CALLAIR

60-7-3 **CallAir** Amdt. 119 Part 507 Federal Register March 25, 1960. Applies to All CallAir Models A-4, A-4 Modified, A-5 Up To and Including Serial Number 292 and A-6 Aircraft Serial Numbers 202, 244, 248, 252, 262, 264, 268, 269, 270 and 271.

CANADAIR

FIGURE 2

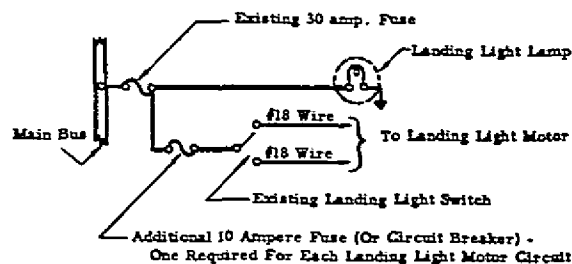
To guard against the possibility of fire or smoke due to inadequate electrical protection of the landing light motor circuits, install a 10-ampere fuse or circuit breaker, in the manner shown in Figure 2 for each motor circuit.

FIGURE 3

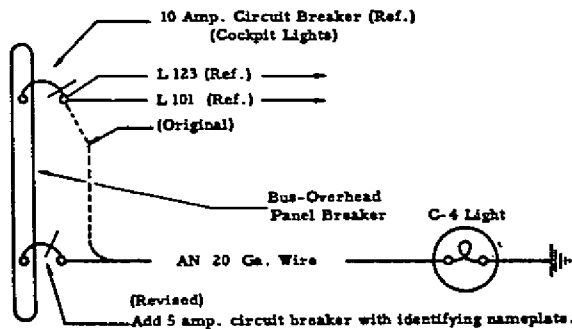
2. Revise the wiring to the C-4 lamp assembly as shown in Figure 3.

FIGURE 4

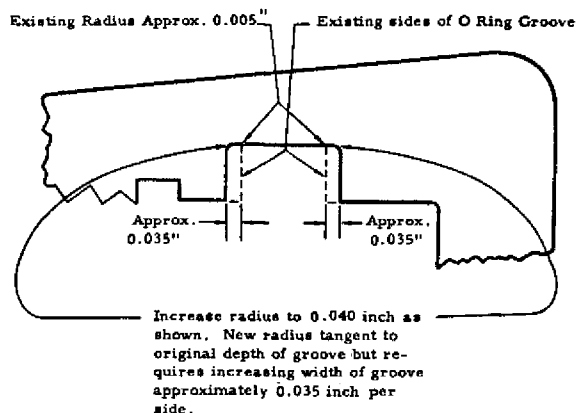
As a result of several failures of the landing gear retraction cylinder head emanating from fatigue cracks occurring in the radius of the O ring groove, it has been found necessary to inspect and rework the landing gear retraction cylinder head to provide a more serviceable part.

Remove the landing gear retraction cylinder head and inspect the upper and lower radii of the O ring groove for cracks by means of a dye penetrant. If cracks are found the part should be replaced. In the event no cracks are present the upper and lower radii of the O ring groove should be increased to 0.040 inch as shown in Figure 4 and again inspected by means of a dye penetrant. If no cracks are found after this

inspection, the part may be returned to service; however, if cracks are evident, the part should be replaced.

NOTE: Smooth machine finish (RMS-32 or better) with no tool marks or discontinuities. No change in size of O ring necessary.
